MFN 09-737

Subject: **Response to a Portion of Request for Additional Information Letter No. 382 Related to ESBWR Design Certification Application, - DCD Tier 2 Section 3.11 - Environmental Qualification of Mechanical and Electrical Equipment; RAI 3.11-28 S01**

**RAI Number 3.11-28 S01**

**DCD Markups for RAI Number 3.11-28 S01**

**Figure 1**

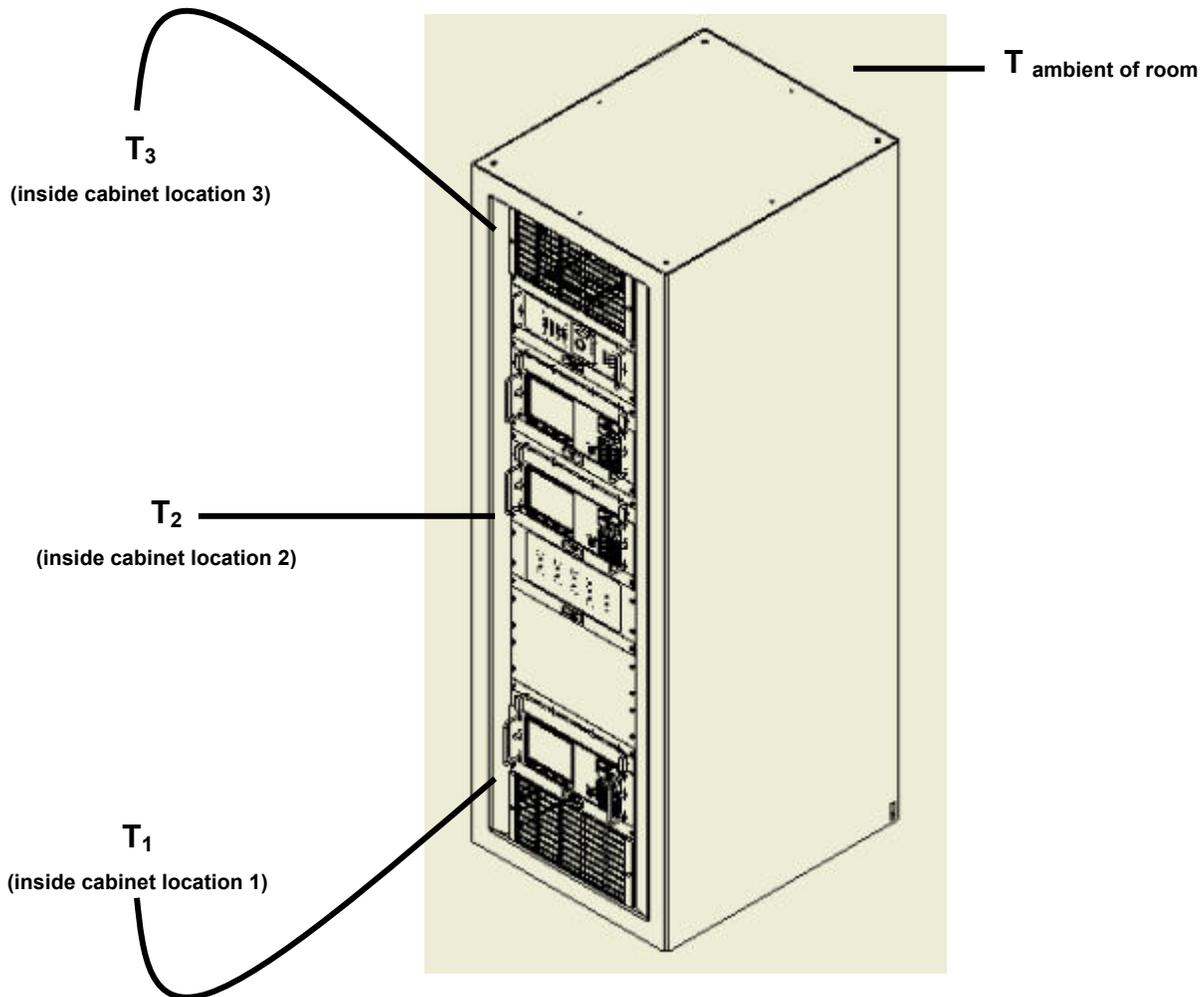
*Provide additional details on how the service temperature of electrical equipment, including Computer-based I&C systems, will be determined for the ESBWR. In particular provide details on this process for equipment that is planned to be located inside electrical cabinets/panels in the RB and the CB. Also, discuss how the service temperature will be determined for equipment in harsh environment.*

The “service temperature” of electrical equipment, including for computer-based I&C, is the ambient temperature of the environment adjacent to the exterior of the equipment’s physical envelope (e.g.; cabinet or enclosure). It is understood that the temperature inside an energized electrical equipment cabinet will be higher than the ambient room temperature of the environment in which it is exposed (see the example in Figure 1 below).

The temperature increase values at certain locations and gradients between locations inside a cabinet is based on many variables, including (but not limited to); thermal conductivity and emissivity of the cabinet itself, number and location of chassis installed, power output or thermal load of each chassis, airflow either natural or forced around and through the cabinet, as well as other heat sinking methods not involving airflow directly.
